# ENVIRONMENTAL RE-EVALUATION FORM

Project Name: I-20, I-26, I-126 Carolina Crossroads Corridor Improvements

# NEPA Re-evaluation

SUPPORTING DOCUMENTATION  
JULY 22, 2020

**CAROLINA CROSSROADS  
 I-26 WESTBOUND RAMP ONTO I-126  
 EASTBOUND AND COLONIAL LIFE BLVD**

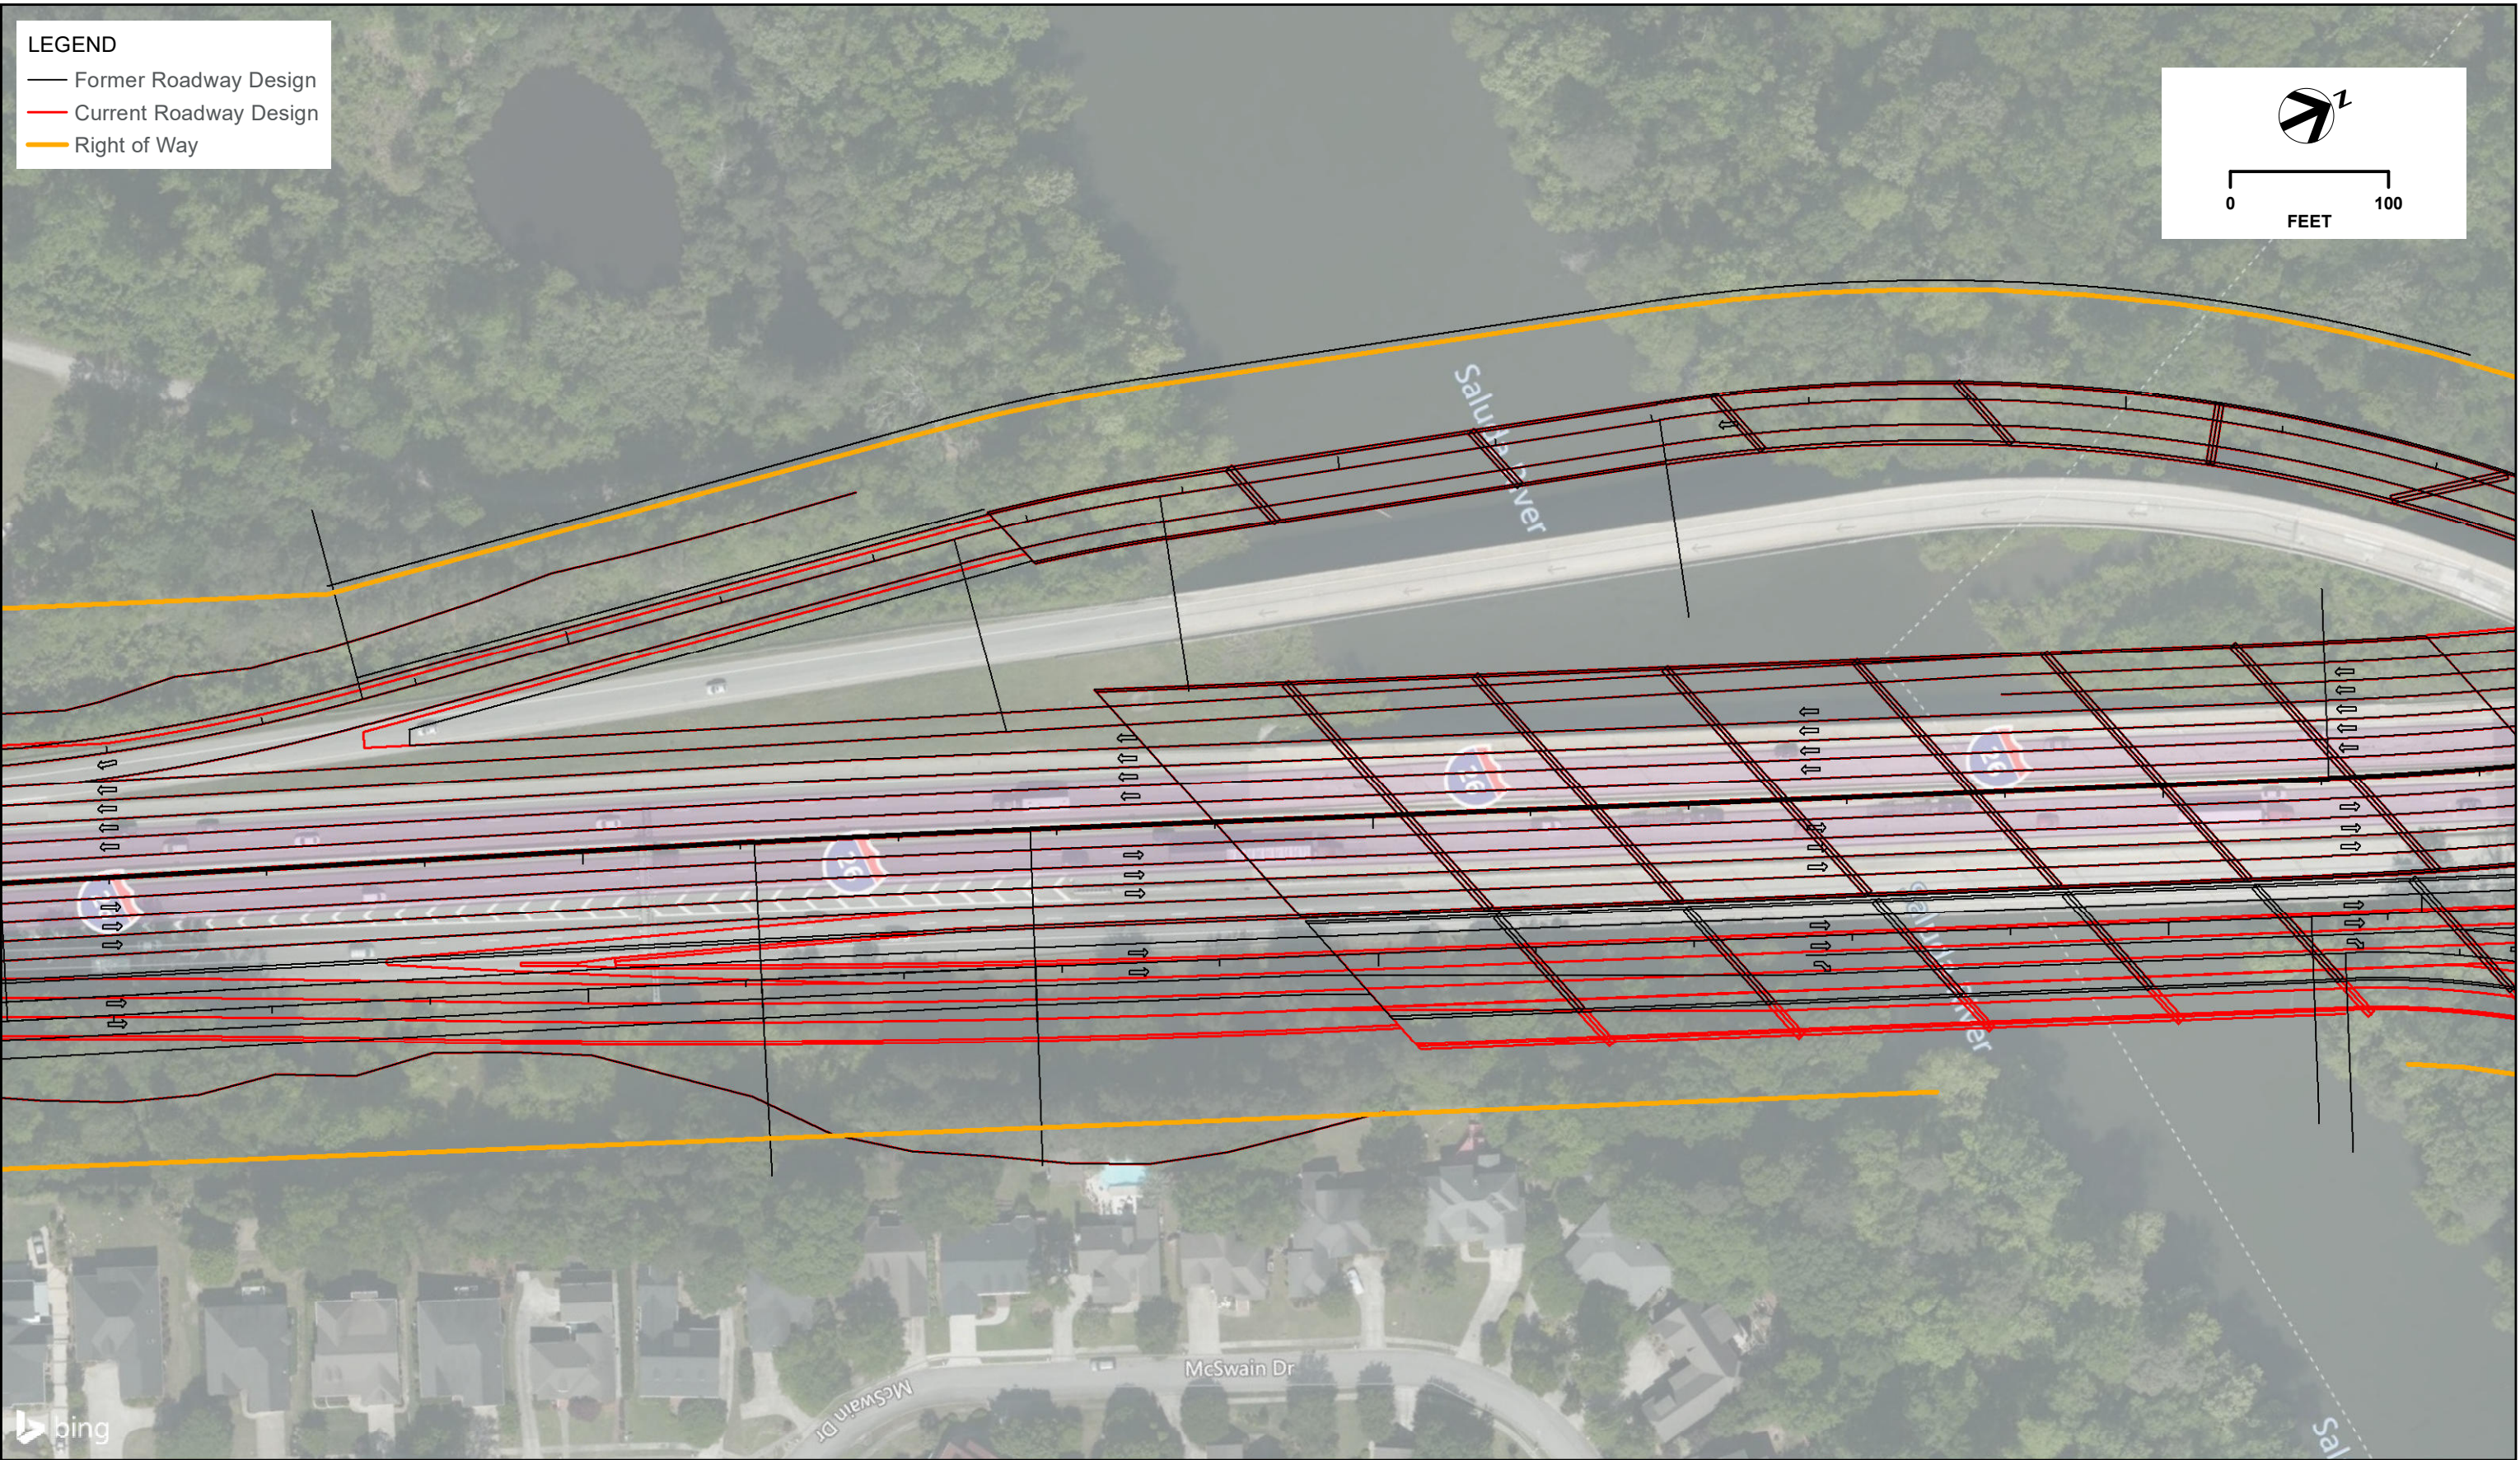
### **I-26 Westbound Ramp onto I-126 Eastbound and Colonial Life Blvd.**

The proposed ramp alignment at the above location proposed in the RPA created a physical overlap between the ramp bridge and the existing I-26 Mainline Bridge over the Saluda River. Since the project is now being constructed in phases through multiple construction contracts and this ramp is constructed as part of the first phase, this physical conflict between the bridges must be resolved to allow the existing bridge to remain in service during construction and in the interim period between construction phases. To resolve this conflict, the ramp has been shifted away from the mainline approximately 20 feet. This change is just to the ramp geometry and does not change the operational function of the proposed exit from I-26 Westbound. The change occurs within the right of way proposed for the Refined RPA. See Figure 2.

As a result of this design change, the traffic noise analysis was updated to account for the ramp shifting closer to the Rivers Edge neighborhood by approximately 22 feet. The noise analysis concluded that the overall number of impacted receivers in the area did not change. The noise barrier analysis still found that a noise barrier at this location was not reasonable. See the Noise Analysis Update memo in Appendix A.

**CAROLINA CROSSROADS  
 I-126 WB EXITS TO COLONIAL LIFE  
 BLVD. AND I-26 EB**

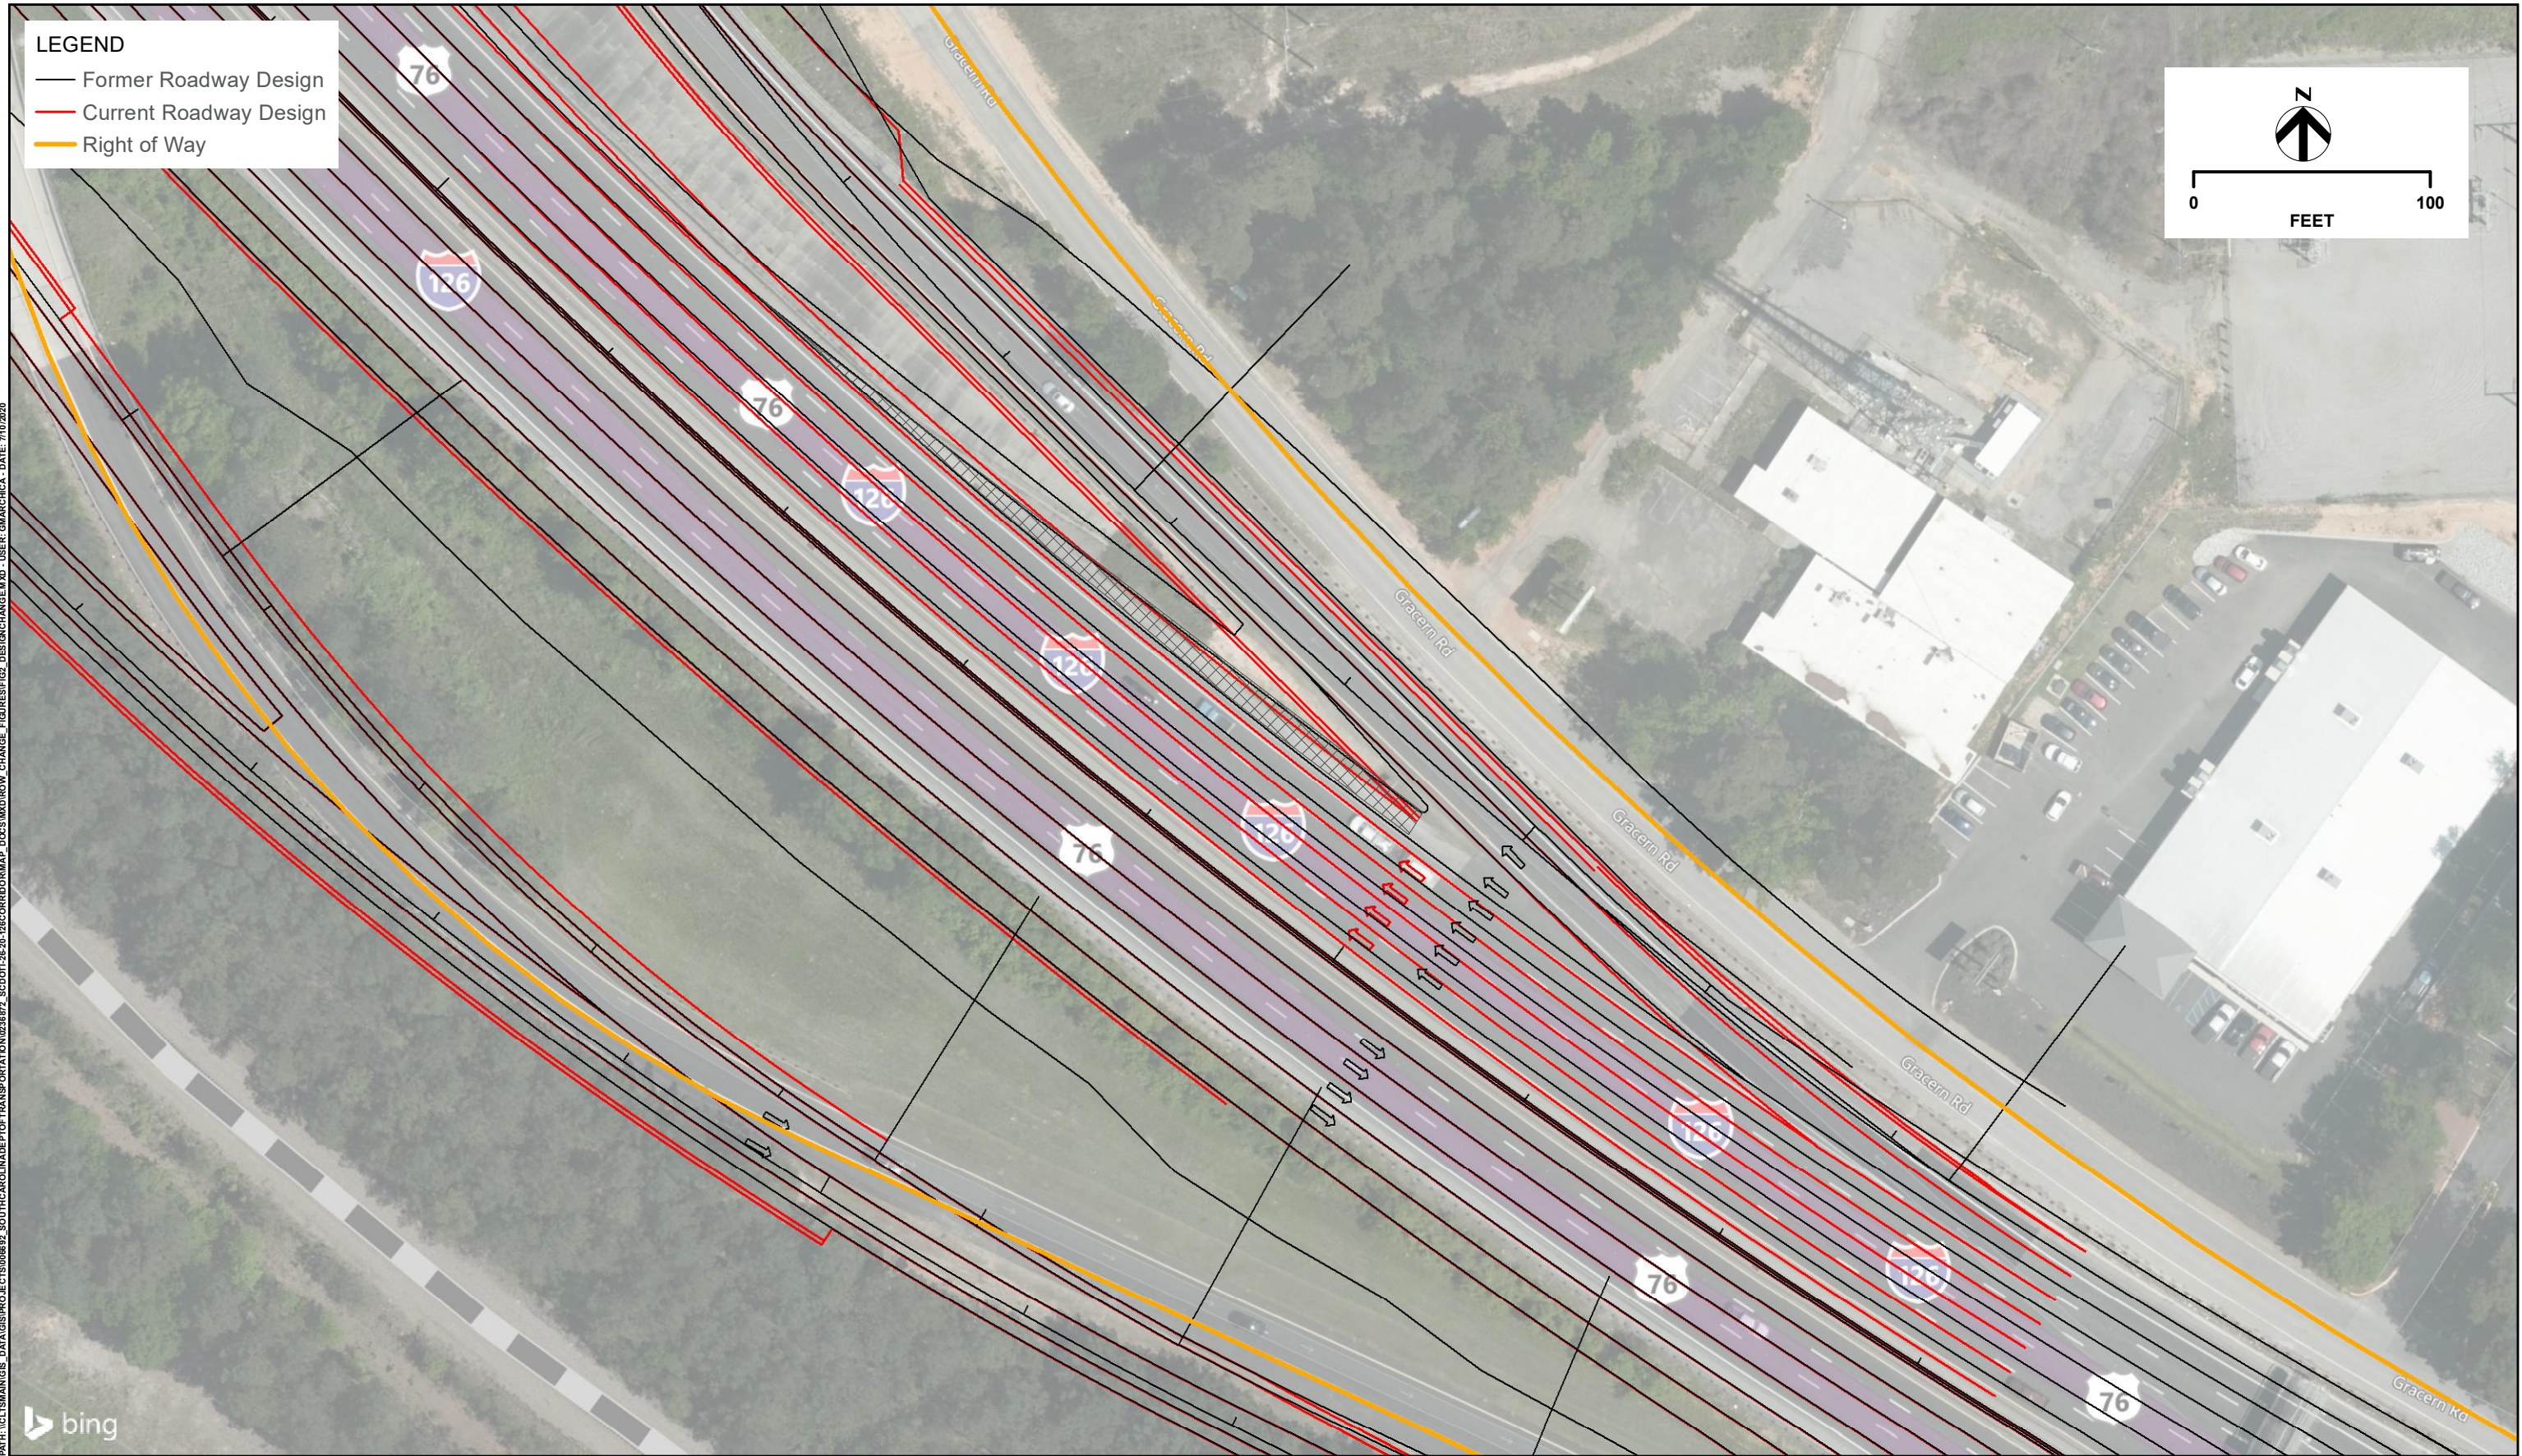
### I-126 WB Exits to Colonial Life Blvd. and I-26 EB

The Refined RPA included a five-lane approach along I-126 Westbound to the Colonial Life Blvd. exit with the exit to Colonial Life Blvd. being a tapered exit and all five through lanes extending through the exit. Beyond the Colonial Life Blvd. exit, the outside lane would become an “Exit Only” lane for the exit to I-26 Eastbound. During the design development, it was discovered that undesirable roadway design exceptions for lane and/or shoulder width would be required to allow for the five through lanes beyond the tapered exit to Colonial Life Blvd. The design was subsequently modified to retain the existing approach to the Colonial Life Blvd. parallel exit with four through lanes and immediately following the exit to Colonial Life Blvd., a deceleration lane for the exit to I-26 Eastbound is developed. This change was incorporated into the project traffic models and it was determined that this change will not adversely impact the I-126 westbound mainline operations during both the morning and afternoon peak hours. The change occurs within the originally proposed footprint of the roadway and within the right of way proposed for the Refined RPA. See Figure 3.

**CAROLINA CROSSROADS  
SALUDA RIVER ACCESS ROAD**

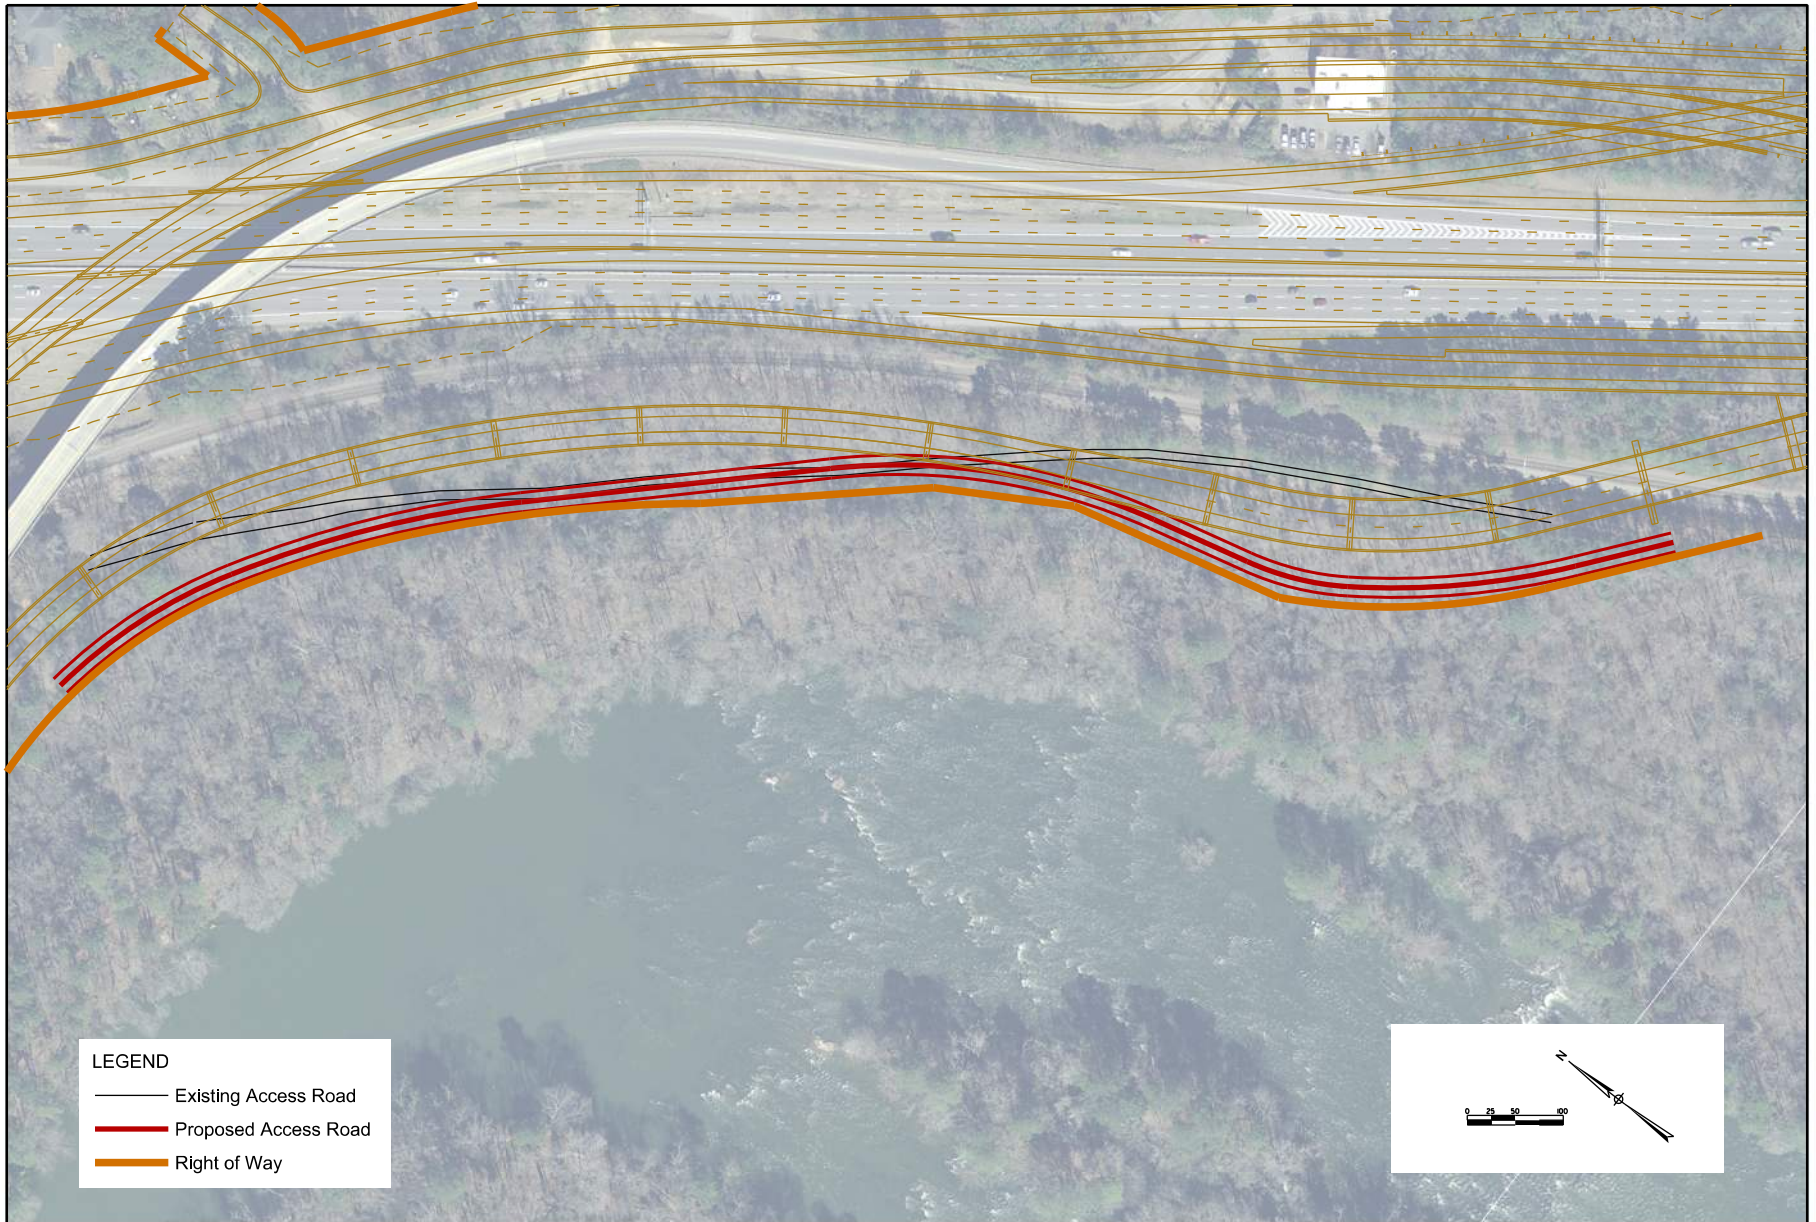
### Saluda River Access Road relocation

SCDOT is currently in the process of purchasing right of way for the project. During the negotiation process with Dominion Energy for the purchase of right-of-way along I-126 near the I-126/I-26 interchange, adjacent to the Saluda River, Dominion Energy identified an existing access/service road along the Saluda River that they currently used for maintenance of transmission lines and access for both the Saluda Riverwalk and Saluda River boat ramp. Emergency services also use the access road for emergency response to the trail and the boat ramp, which provides access for river rescues. The current design would require the elimination of the existing access road. SCDOT will be required to re-establish this access road within the proposed right of way acquired for the Carolina Crossroads project. The relocated roadway is expected to be reconstructed along the right of way line, adjacent to I-126 and the interchange ramps. The road was designed to avoid impacts to the Saluda Canal, which is an historic resource. See Figure 4. The proposed relocation of the access would increase impacts for Wetlands 25 and 26 by a total of 0.24 acres of fill and 0.19 acres of clearing and Tributaries 45 and 46 by a total of 53 linear feet. However, the overall wetland and stream impacts included in the USACE Individual Permit (IP) are lower than the impacts documented in the FEIS/ROD, as noted in Table 1.
